<b>marantz®</b> <b>SERVICE BULLETIN</b>		Date: 10-Dec.-2004	Model: CD5400
		Page: 1 / 1	REF.NBR: MZ04-082
Level		Application:	
★ ★ ★		See below	
		Subject: The sound jump sometimes occurs during Playback CD.	
		Int.ref:

**Remove C156**

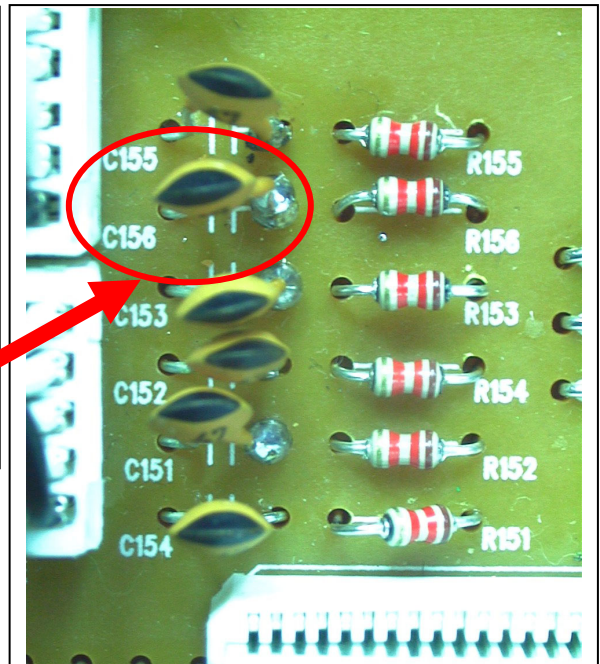
C156 Capacitor connected to the CLOCK line of DSP changed the signal, and microprocessor cannot recognize correct data.

**POS.NO C156 (Ceramic Capacitor 47pF) is removed.**
